Monticello Nuclear Generating Plant  
2807 W County Road 75  
Monticello, MN 55362

L-MT-12-002  
10 CFR 50.90

License Amendment Request: Revise and Relocate Pressure Temperature Curves to a  
Pressure Temperature Limits Report

**REVISE THE TECHNICAL SPECIFICATIONS TO INCLUDE A  
PRESSURE TEMPERATURE LIMITS REPORT**

Figure 3.4.9-1  
Core Beltline Operating Limits Curve Adjustment Versus Fluence

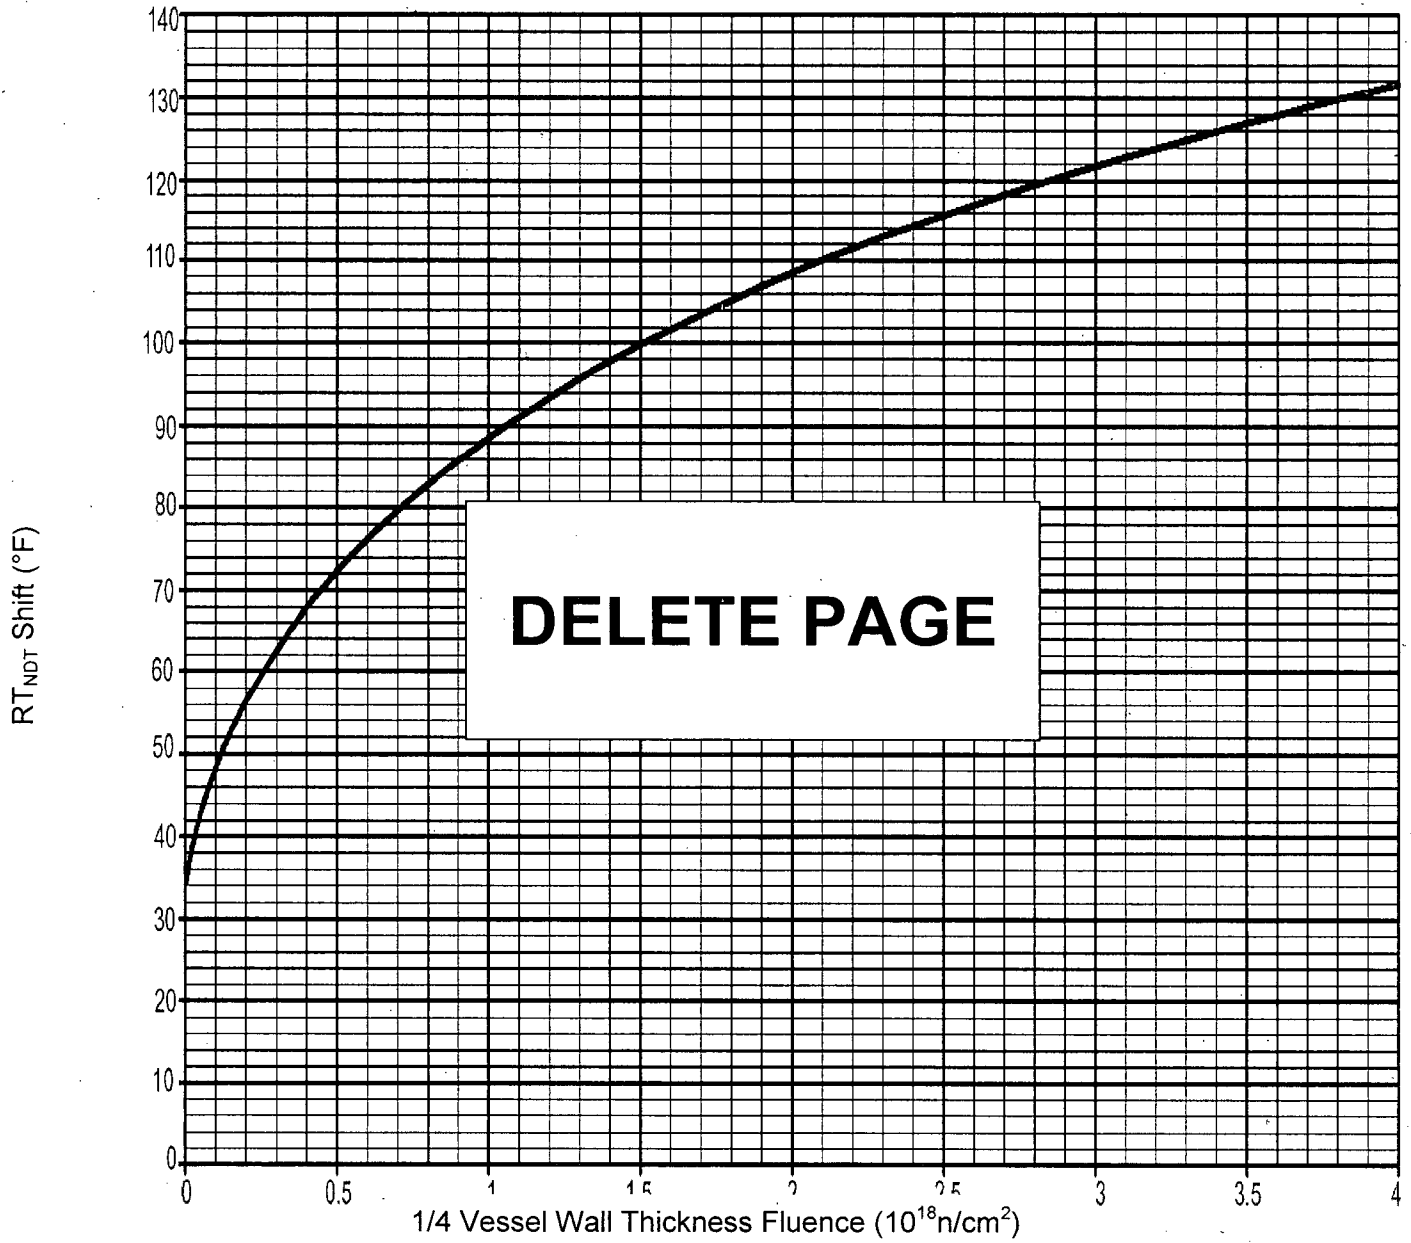
- The first non-conservative TS condition discovered is that with incorporation of recent surveillance specimen capsule results TS Figure 3.4.9-1, "Core Beltline Operating Limits Versus Fluence," becomes non-conservative in approximately 2026. This figure is part of the current MNGP specific methodology (not part of the SIA methodology) and will be removed with approval of this amendment, eliminating this condition.
- The second non-conservative TS condition is that sufficient fluence had accumulated for the recirculation inlet nozzles to enter the beltline region. These nozzles are now a limiting component under low temperature / low pressure conditions. Procedural controls have been put in place to prevent entry into this region during hydrostatic testing.

1. Incorporation of recent surveillance specimen results have resulted in current TS Figure 3.4.9-1, "Core Beltline Operating Limits Versus Fluence," curve becoming non-conservative in approximately 2026. (This curve is part of the current MNGP P-T methodology and will be eliminated with adoption of the SIA methodology via this amendment.)
2. Determination that the recirculation inlet (N2) nozzles are in the beltline region<sup>(4)</sup> of the vessel and are a limiting component for low temperature / low pressure conditions.

- 6) Remove the present P-T curves, i.e., Figure 3.4.9-1 through Figure 3.4.9-4.
  - 7) Add a new Specification 5.6.5, "Reactor Coolant System (RCS) Pressure and Temperature Limits Report (PTLR)," to Subsection 5.6, "Reporting Requirements," in Section 5.0, "Administrative Controls." The format and content is according to TSTF-419-A. This new specification:

Calculational results incorporating these changes indicate that current TS Figure 3.4.9-1, "Core Beltline Operating Limits Curve Adjustment Versus Fluence," will become non-conservative in approximately 2025 at the current rate of fluence accumulation. This condition is being treated as a non-conservative TS in accordance with NRC Administrative Letter 98-10.

Figure 3.4.9-1 is part of the current MNGP specific P-T methodology. This figure allows the core beltline operating limits to be adjusted for fluence under the current MNGP methodology. This adjustment capability is NOT part of the BWROG SIA methodology. Figure 3.4.9-1 will be eliminated following adoption by the MNGP of the BWROG SIA methodology with the approval of this amendment – precluding this condition in the future.

Figure 3.4.9-4  
RCS Pressure Versus Temperature Limits  
Critical Operation

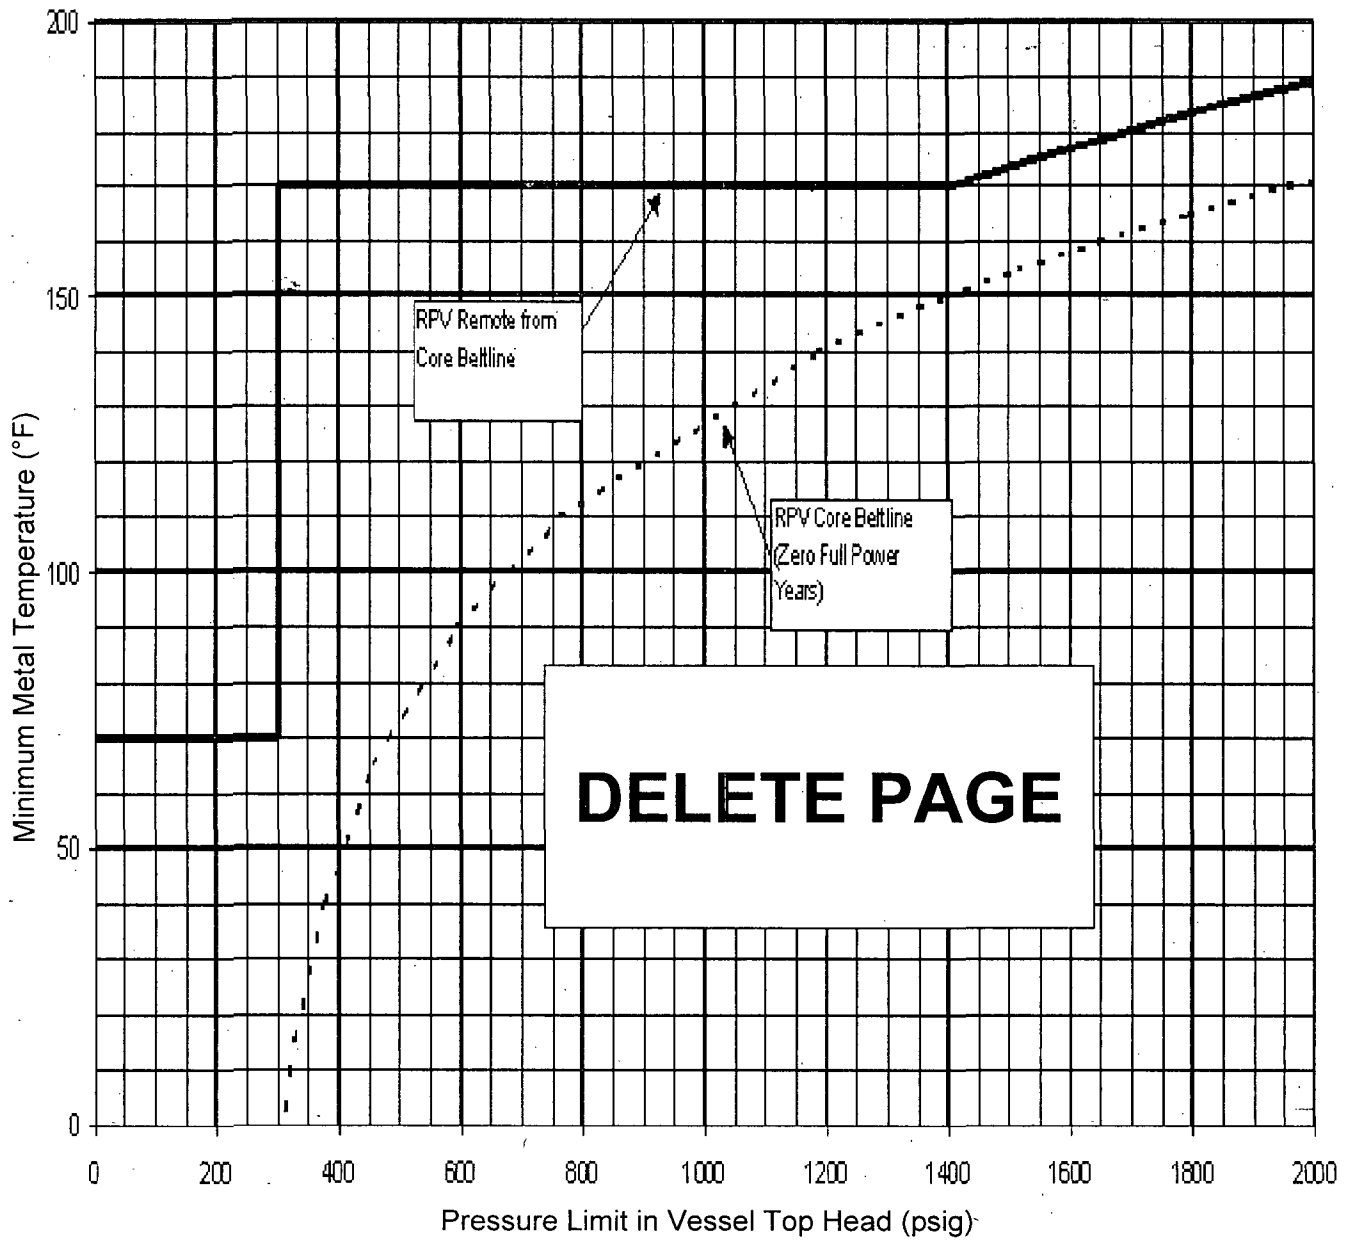
~~This SR has been modified by a Note that requires Figure 3.4.9-4 to be adjusted as required by Figure 3.4.9-1 (core beltline temperature adjustment) for the reactor vessel shell and fluid temperatures. This ensures the proper RCS pressure and temperature limits are met based on reactor fluence.~~
